Manchester Art Gallery

Roof Lantern Replacement [Ref: 137015/LO/2023]
Discharge of Condition 3, Item 3
December 2024

TITLE:
REPLACEMENT LANTERN LIGHT
RAFTER AND HIP DETAILS

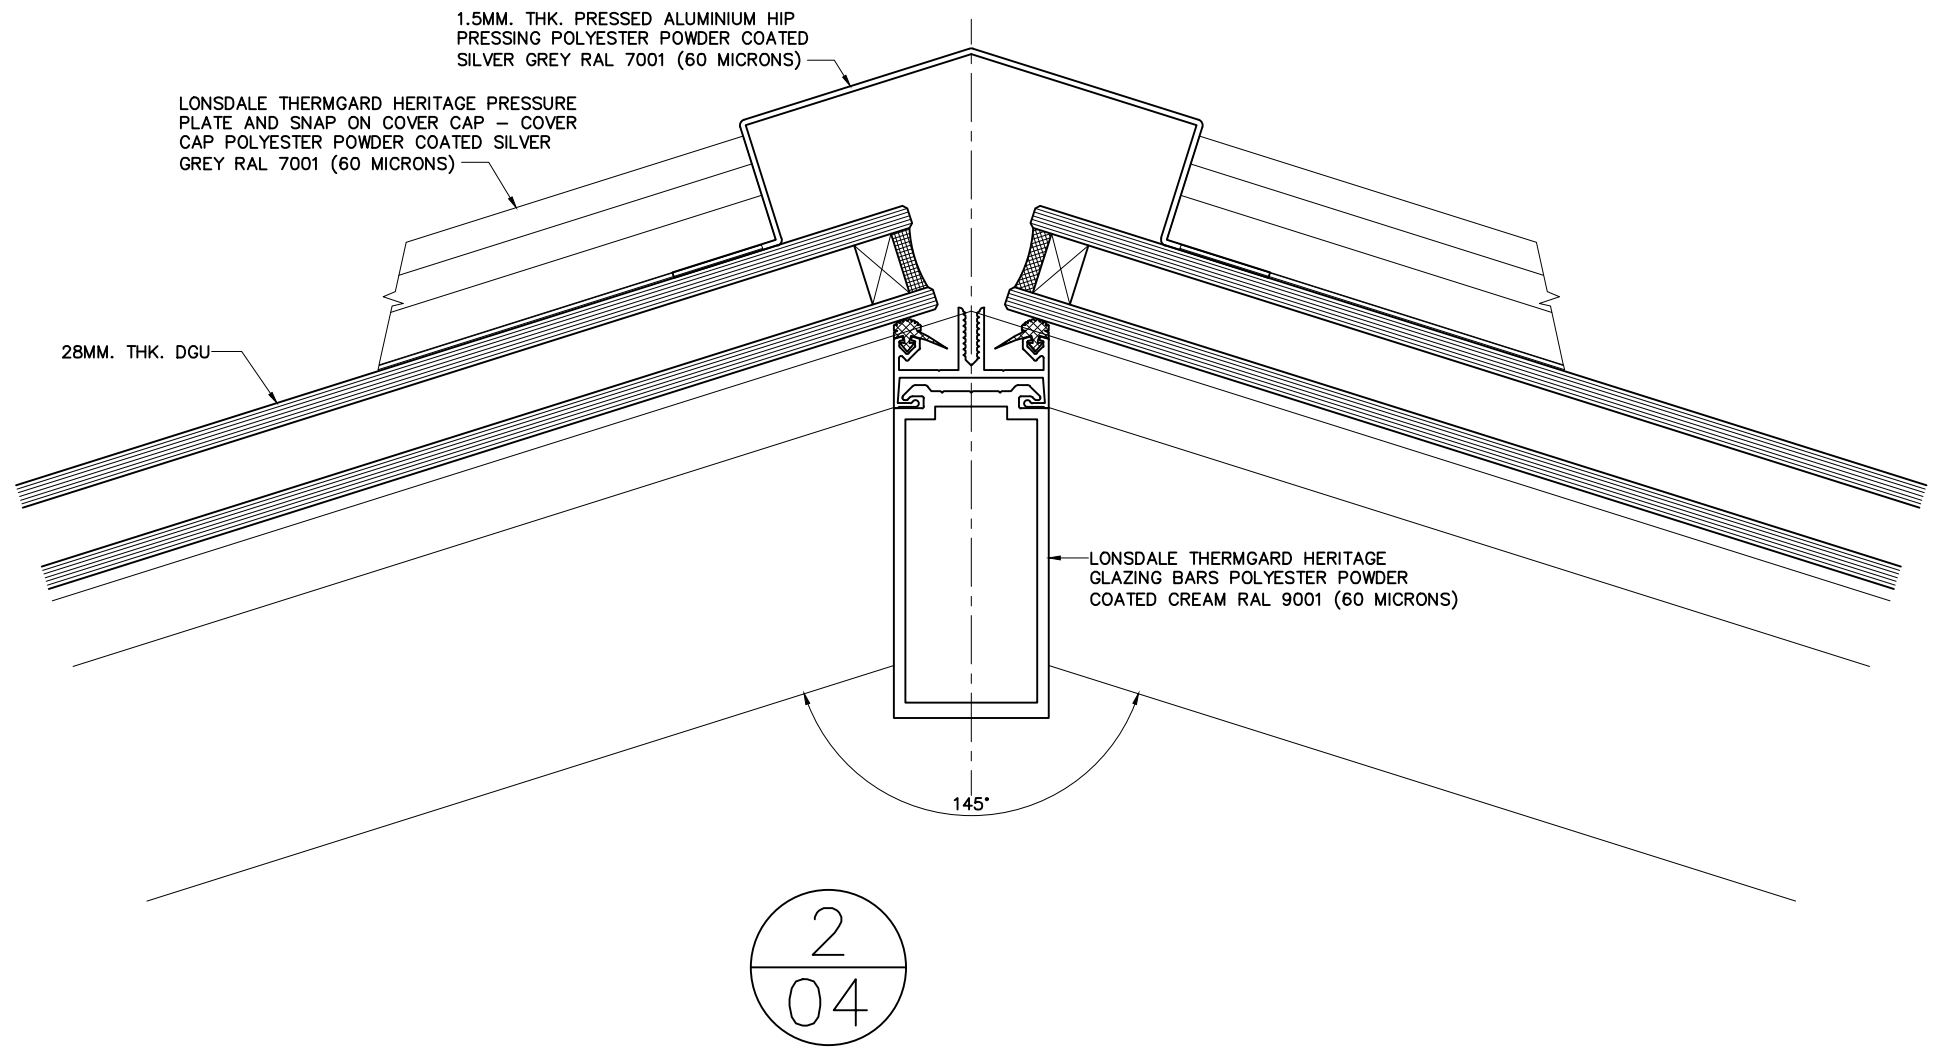
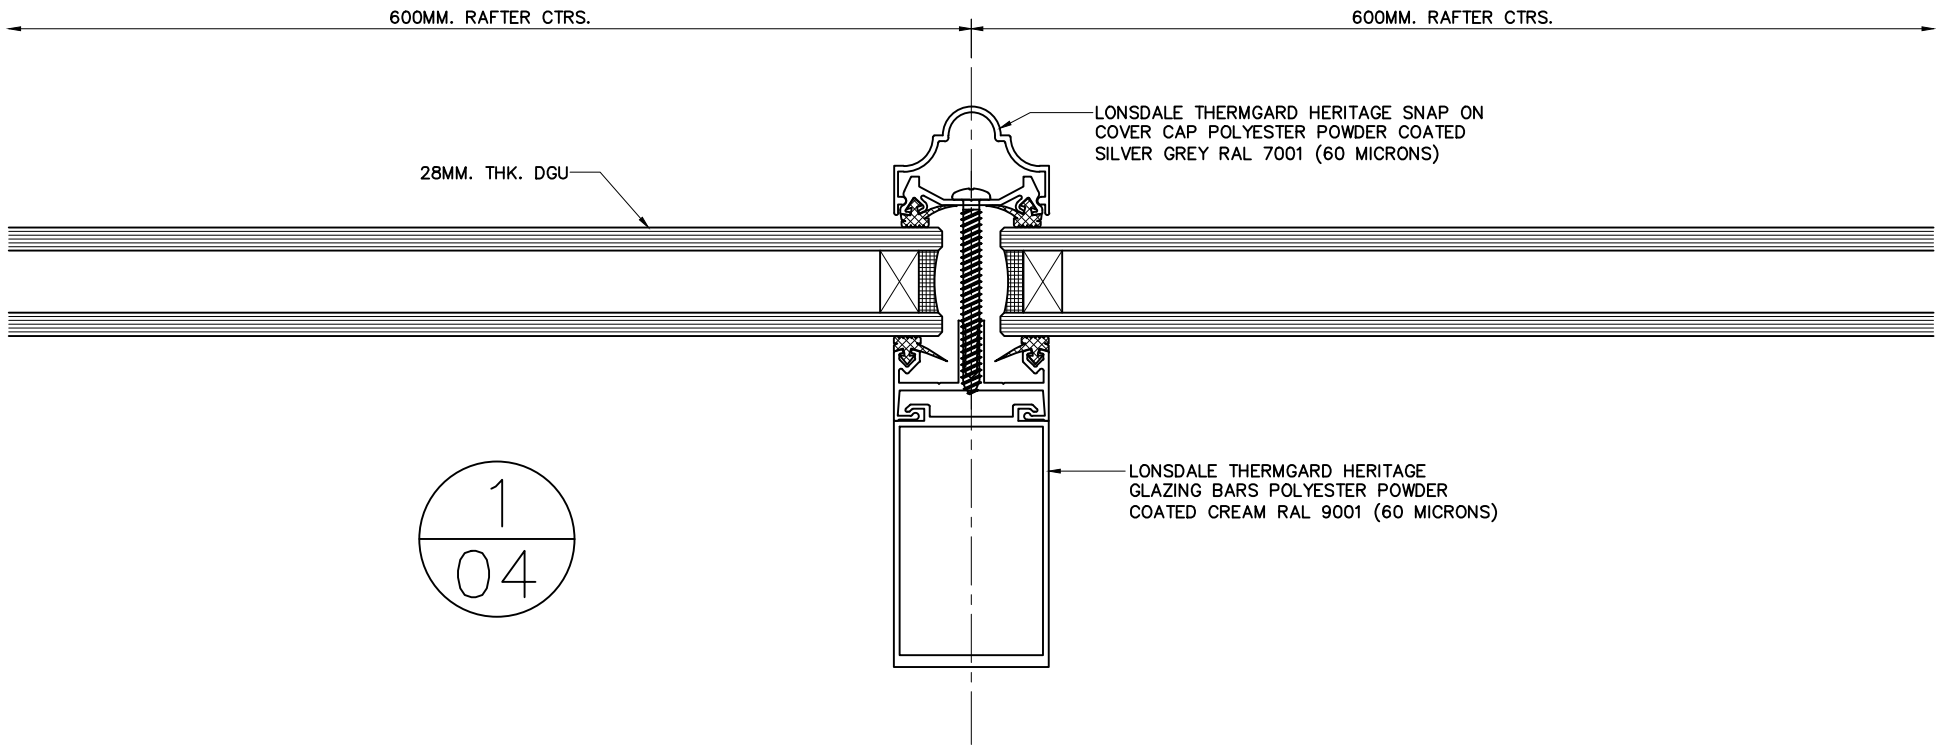
C01	INTERNAL BESPOKE TIMBER CAPPING REMOVED; 60 MICRONS ADDED TO ALL COLOURS; TITLE BLOCK REVISED	PD	22.11.2024
E	HIP DETAIL 2 REVISED ISSUED FOR CONSTRUCTION	PD	6.10.2024
D	INTERNAL HERITAGE PRESSURE PLATE AND SNAP ON COVER CAP REPLACED WITH BESPOKE TIMBER CAPPING	PD	13.2.2024
C	RAFTER ALTERED FROM 100/1 40MM. TO 100/2 63.5MM.	PD	9.1.2024
B	RAFTER BOX SECTIONS ALTERED TO ACCEPT HERITAGE CAP INTERNALLY; HIP ANGLE REVISED TO SUIT NEW ROOF PITCH OF 25°	PD	14.12.2023
A	RAFTER BOX SECTIONS ALTERED TO HERITAGE SECTIONS; HIP RAFTER BOX ADDED	PD	8.12.2023
REV:	DESCRIPTION:	BY:	DATE:
